SERVICE BULLETIN

Reference No 277

**TRANSMITTAL LETTER
FOR
SERVICE BULLETIN NMD-57-10 Rev 2**

**WING STRUT BOLT REPLACEMENT
(MOD N654A AND MOD N654B)**

Figure 1 Special Line Reamers - Upper Strut Fittings

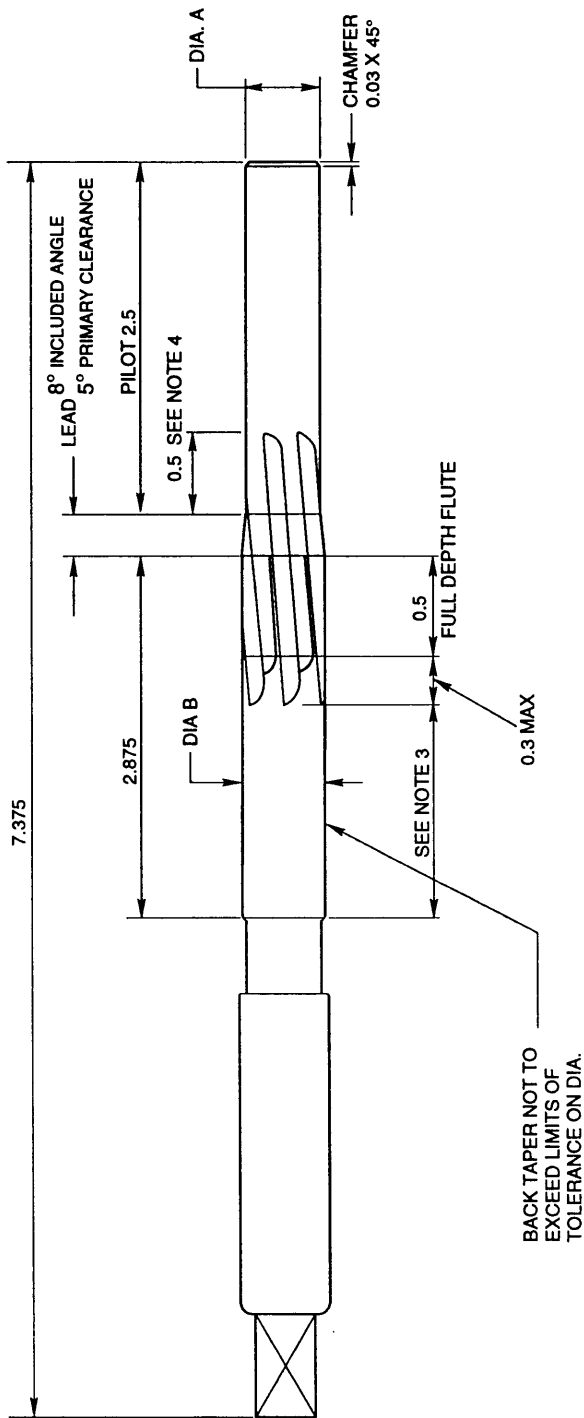
To include correct reamer part numbers and to revise reamer manufacturing details shown in Figure 1 to comply with the latest engineering drawing.

In order to improve the performance of the reamer the flute design has been changed. Figure 1 has been revised to incorporate these changes.

In order to improve the performance of the reamer the flute design has been changed. Figure 1 has been revised to incorporate these changes.

- NOTES:
1. EXCEPT AS SHOWN, REAMER IS A HELICAL FLUTED (6 FLUTES) HAND REAMER MADE FROM HIGH SPEED STEEL - COMMERCIAL TO ANSI B 94.2-1964
 2. FOLLOWING GRINDING, A TRIAL HOLE IN QQ-A-225/6 T851 MATERIAL (PREVIOUSLY PILOT REAMED—REFER TABLE) IS TO BE REAMED USING SUITABLE LUBRICANT. FINISHED HOLE DIAMETER IS TO BE AS PER TABLE AND AT LEAST THREE FLUTES MUST BE SHARING THE CUTTING. REAMER TO BE RE GROUND OR STONED UNTIL THESE CONDITIONS ARE MET
 3. FLUTES NOT REQUIRED OVER THIS LENGTH
 4. NO CUTTING EDGES OVER THIS LENGTH
